Detailed Site Plan Chipotle at Mill Branch Crossing

DSP-20003-03

STAFF REPORT

SUBJECT: Detailed Site Plan DSP-20003-03
Chipotle at Mill Branch Crossing

Figure 1: Proposed Parcel with subject development

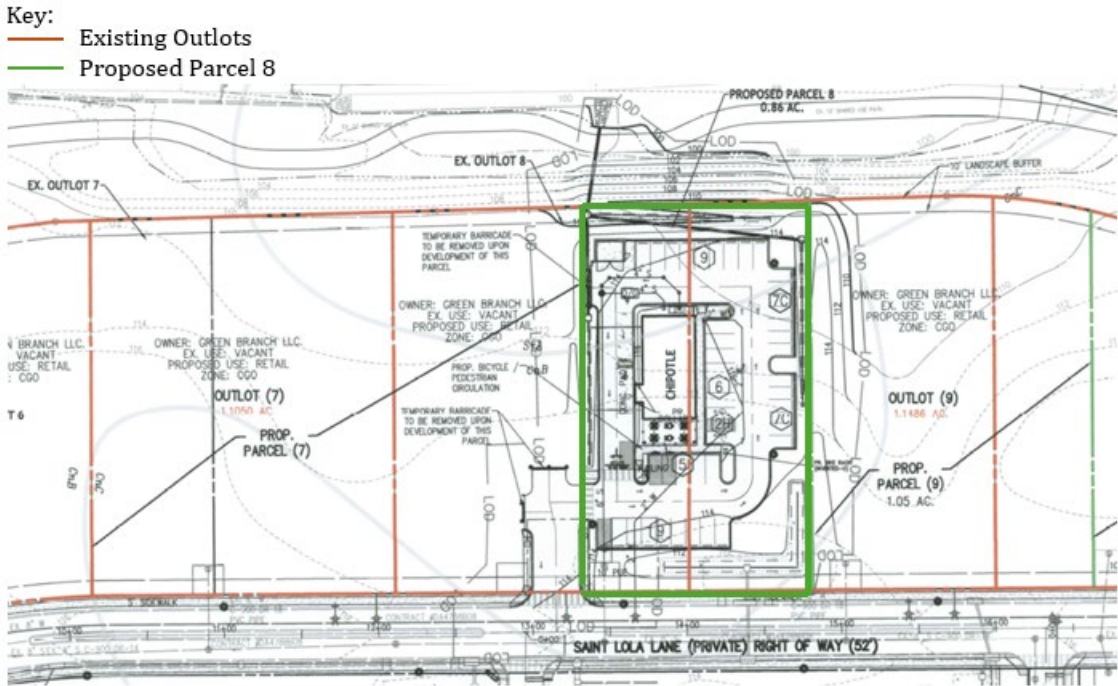
Notes: *Under the original DSP-20003, only infrastructure was approved and no final design for development of the commercial area was approved. Given final configuration of the commercial parcels was unknown at that time, since specific tenants and buildings were not part of that approval, the commercial area was platted as outlots to facilitate grading while indicating future DSP approval for the commercial development and final parcel configuration would still be needed. The property is currently comprised of part of existing Outlots 8 and 9, recorded in Plat Book ME 262 page 52 of the Prince George’s County Land Records. However, the general notes on Sheet DSP-1 and associated plans show two existing outlots (Outlots 8 and 9) and propose two new parcels (Parcels 8 and 9). While the plans reflect the area of the DSP for proposed Parcel 8 (outlined in green), access to the site occurs on abutting proposed Parcel 7 (part of existing Outlot 8). Development of proposed Parcel 9 is being processed under a separate DSP amendment, which was reviewed by the Prince George’s County Planning Board at a hearing on January 9, 2025. Conditions are included herein requiring the applicant to revise the

coversheet and subsequent plan sheets to reflect the specific subject property area of amendment for this DSP, to include parts of existing Outlots 8 and 9 and proposed Parcels 7 and 8, and to show other adjacent lots for future development as outlots with their current platted correlating number, unless having been superseded by an approved DSP amendment.

**Given the clarification on the area of amendment to be made in accordance with the above footnote, a condition is included herein requiring the applicant to revise the total acreage to coincide with proposed Parcels 7 and 8.

1. Prior to certificate approval of the detailed site plan (DSP), the following revisions shall be made, or information should be provided:
 - a. Revise the site data, including the total acreage, cover sheet, and plans to identify the subject property of this DSP amendment as proposed Parcels 7 and 8, with the abutting lots retaining an outlot designation for future development, unless having been superseded by an approved DSP amendment.

Figure 2: Detailed Site Plan

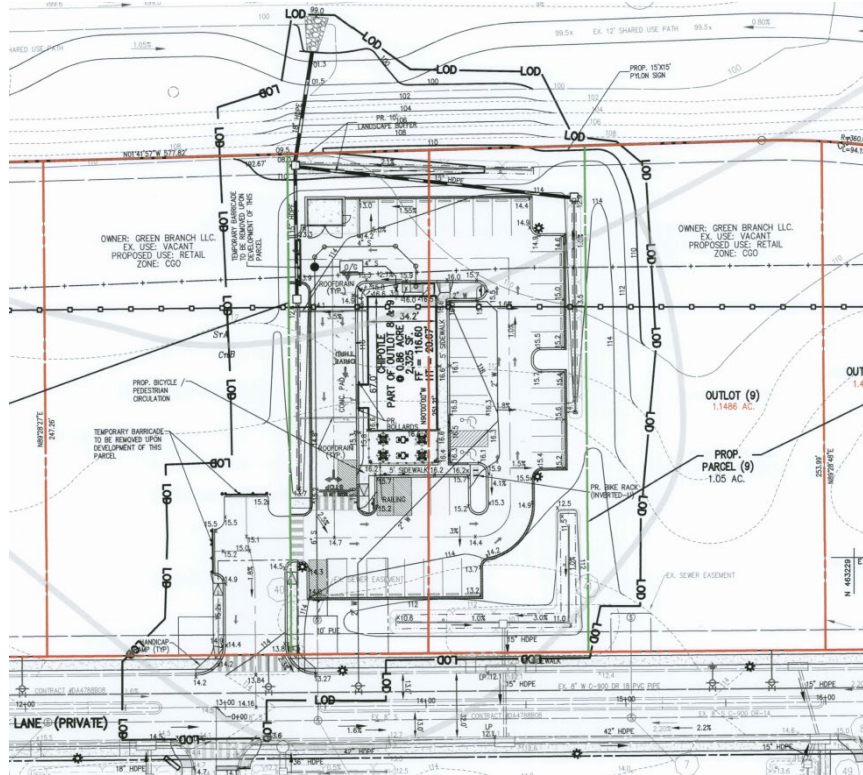
Lighting for this DSP has been discussed in Finding 6 above, demonstrating adequate illumination for users and for the site in the evening. The lighting plans do not specifically indicate that the fixtures are full cut off. A condition has been included herein requiring full cut off fixtures.

- b. Revise General Note 22 to reflect the correct approval dates of the previously approved applications.
 - c. Provide notes on lighting details stating lighting fixtures will be full cut-off.
